OUT18/6607

**Santos Narrabri Gas Project (SSD6456)
Comment on the Response to Submissions (RTS)**

Attachment A

Attachment B

Figure 1 Map of Recommended Locations

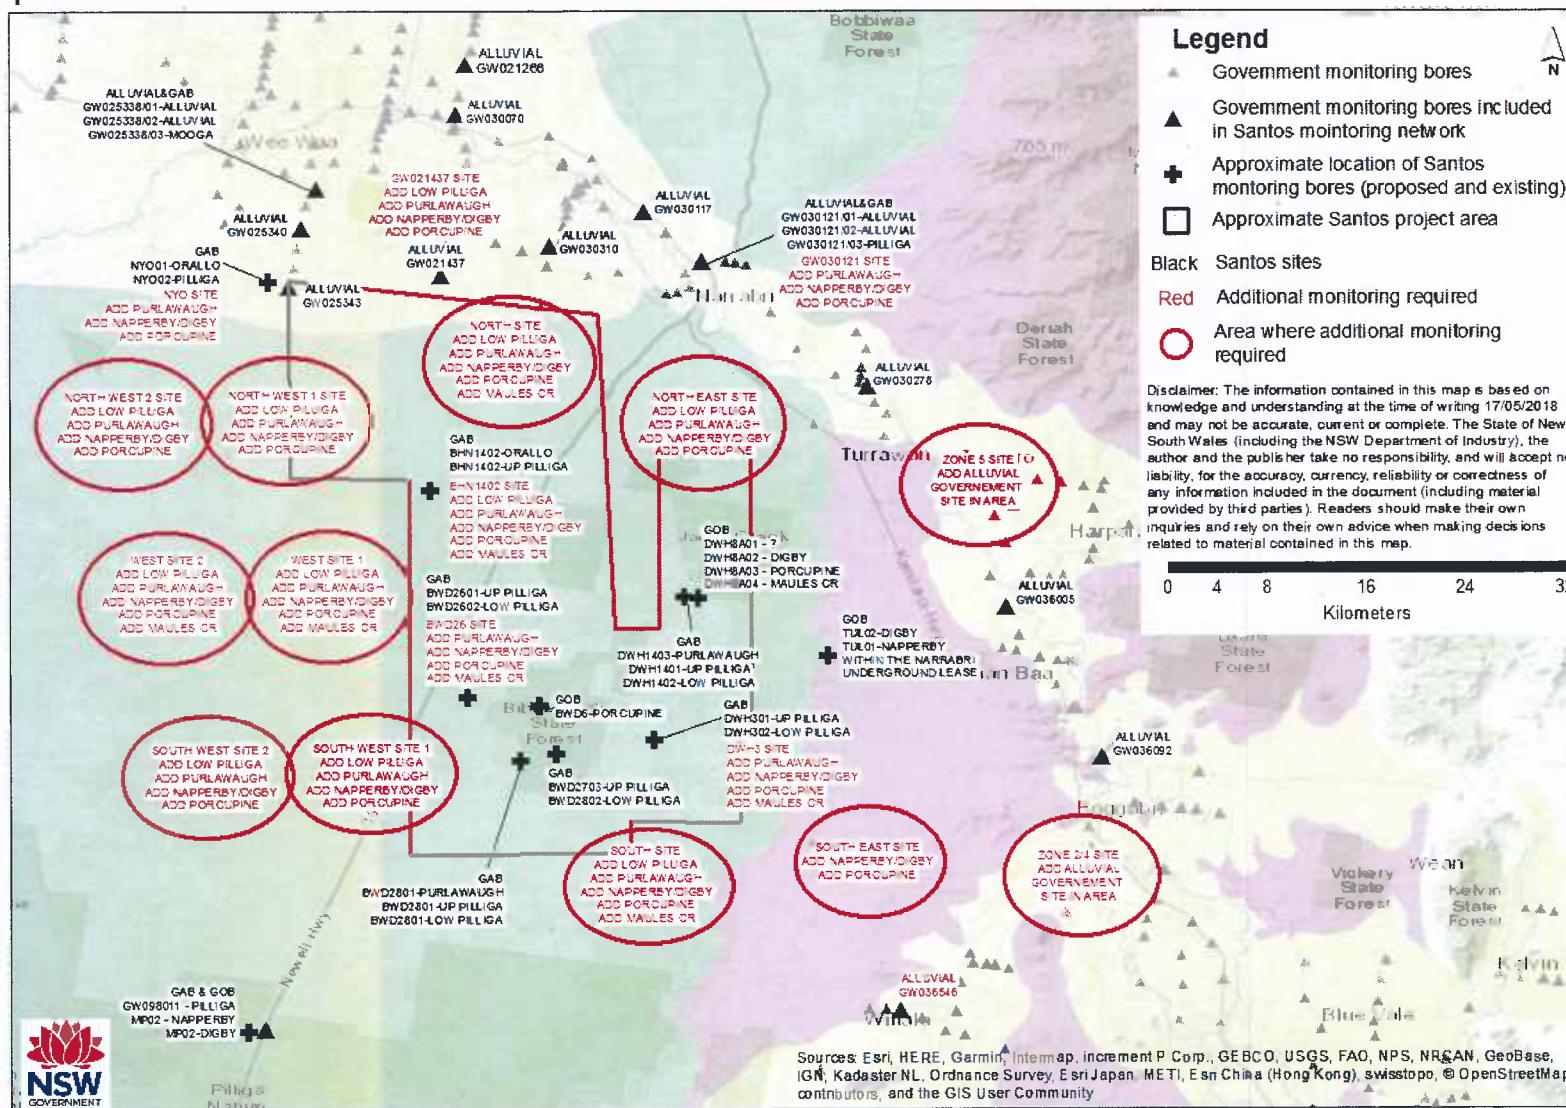
The proposed additional monitoring sites required for the development are shown in Figure 1 and listed in Table 1.

- At identified Government monitoring sites currently included in the WMP with multiple pipes at different depths identified by the same 'GW' number; all pipes must be included in the monitoring network.
- Consideration can be made for using existing Government alluvial monitoring bores at the recommended locations.

- As a minimum all identified sentinel monitoring bores specified in Table 1 shall be in place and equipped with appropriate water level measuring devices to enable collection of data for a minimum of 1 year:
 - prior to the commencement of any production or
 - prior to the requirement for the model to be updated by year 3 post project approval.

- All additional bores specified in Table 1 shall be in place and equipped with appropriate water level measuring devices to enable collection of data for a minimum of 1 year prior to updating the model to a Class 3 model by year 6.
- All existing Santos monitoring sites are to be included in the monitoring network.
